Sub. : Inspection reports on status of implementation of CEPI Action Plans at (i) Ranipet, Vellore District, Tamil Nadu (ii) Cuddalore Sipcot Industrial Complex, Cuddalore Dist. Tamil Nadu - regarding

**Inspection report on status of  
implementation of CEPI Action Plans at  
Ranipet,  
Vellore District, Tamil Nadu**

**South Zonal  
Office,  
Bangalore**

Fig 1: Post Bed Reactor

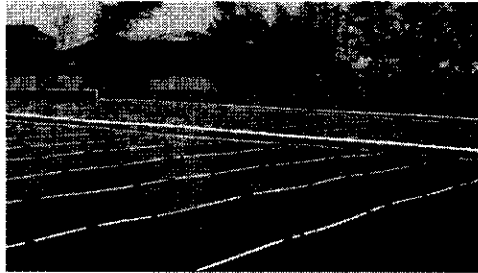
<p>generation to reduce effluent quantity from 220 kld to 195 kld.</p> <ul style="list-style-type: none"> <li>• Installation of post bed reactor at the phthalic Anhydride plant to reduce Tarry distillation Residue.</li> <li>• Physical, chemical and biological followed by ZLD system to be provide</li> </ul>	<p>Post bed reactor is installed and claiming that Tarry distillation is reduced from 15 tons/year to 13.5 T/y.</p> <p>Installed physical, chemical, biological followed by R.O. system. R.O reject is being stored in the enhanced solar evaporation.</p>	<ul style="list-style-type: none"> <li>➤ No provisions are made available to verify the same.</li> <li>➤ The unit claims that their R.O. is operating at 85 % efficiency and generating R.O. reject of 30 kld. The R.O permeate is being used as cooling tower make up and R.O. reject is being sent to solar evaporation pond of size 2250 m<sup>2</sup>. During inspection, the nozzles of the pan were found to be choked and the pan was filled with the R.O. reject and it was found to be overflowing.</li> </ul>

Fig 7: Online VOC Meter

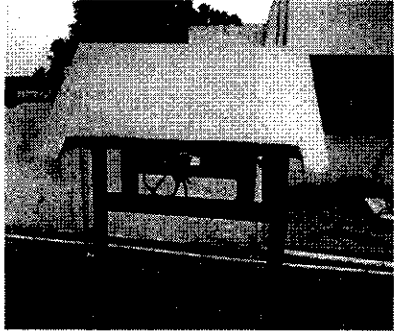
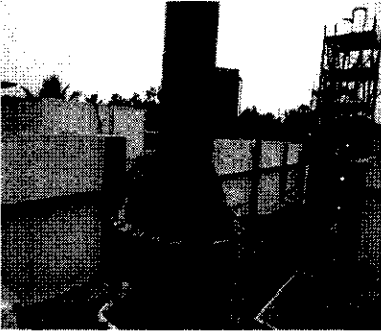
<p><b>Source Emission:</b></p> <ul style="list-style-type: none"> <li>• To install Wet Scrubber, Condensers, Cyclone separator with Dust collector</li> <li>• Online monitoring system for CO, VOC to be connected.</li> </ul>	<p>The unit has installed Wet Scrubber, Condensers, Cyclone separator with Dust collector</p> <p>The unit has installed CO, VOC monitoring system to 1 stack only.</p>	<ul style="list-style-type: none"> <li>➤ The unit has installed wet scrubber, condenser, cyclone separator with dust collector in process. The team has made physical verification, for working condition of control measures, in- depth monitoring is required.</li> <li>➤ Out of three stacks, one stack is having online VOC, CO meter and the same is connected to <b>TNPCB Care Air Centre</b>. For other <b>02 stacks no VOC, CO meter is installed. During inspection it was found that HC of 15.14 ppm and CO of 26.3 mg/m<sup>3</sup>.</b></li> </ul>

Fig 26: Online SO<sub>2</sub> monitoring system

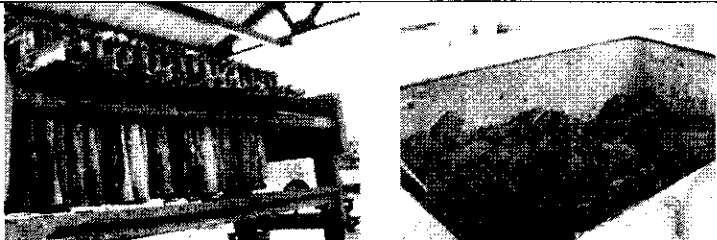
➤ At the time of inspection the Online SO<sub>2</sub> monitoring system was showing 20 ppm and the same has been connected to **TNPCB Care Air centre.**
